## OSM/IN DECISION

<b>Standard:</b>	EN 61058-1:2002 + A2:2008	<b>Sub clause:</b>	13 – 17	<b>Sheet N°:</b>	OSM/IN 243
<b>Subject:</b>	Rotary switches for “cooking range” (Endurance test)	<b>Key words:</b>	- cooking range switch - multiple poles	<b>Meeting N°:</b>	19 (2009)
				<b>Item:</b>	4.1.2

**Figure 1**  
(Switch locked in fully open position)

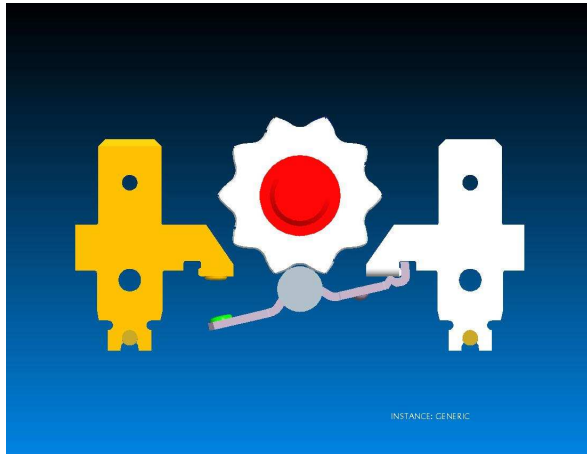
Sub-cl. 17.2.5.3 Insulating compliance (1500V); in fully open position (Figure 1) and in intermediate position of locking mechanism (Figure 2)

Although the compliance criteria of Clause 17 are met in this case, the criteria of Clause 13 shall also be met.

This can be considered as invoked by the requirements of clause 4, ie: “*In general compliance is to be checked by carrying out all the relevant tests.*”. Obviously in this case the requirements of clause 13, following clause 17, are “*the relevant tests*”.

**Figure 3**  
**(Switch in semi-OFF position)**  
**Requirements of Cl.15.3 (75% of corresponding test voltage) are not met**

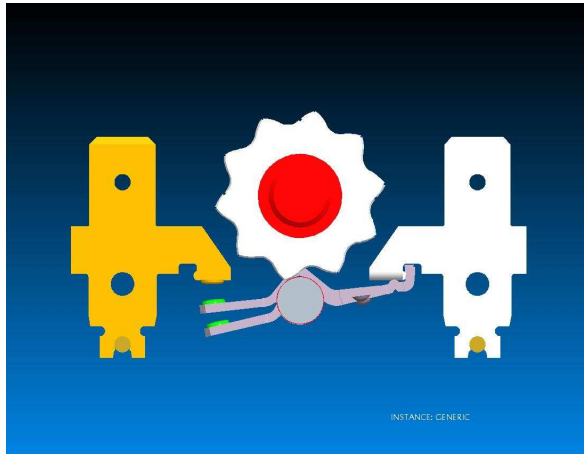
After the appropriate tests of 17.2.4 locking mechanism is worn out to such extent that requirements of Sub-cl. 13.2 and Sub-cl. 13.3 are not met anymore. It is possible to set actuating mean in several positions in which moving contacts are rest in positions in which compliance with Sub-cl. 13.2 and 13.3 are not met. An example is shown in Figure 3.

Is it required that requirements of Cl. 13 are met after tests of Cl. 17 ?

Or it is enough that switch withstand heating test in closed position and dielectric strength test with 75% of corresponding test voltage in fully open position?
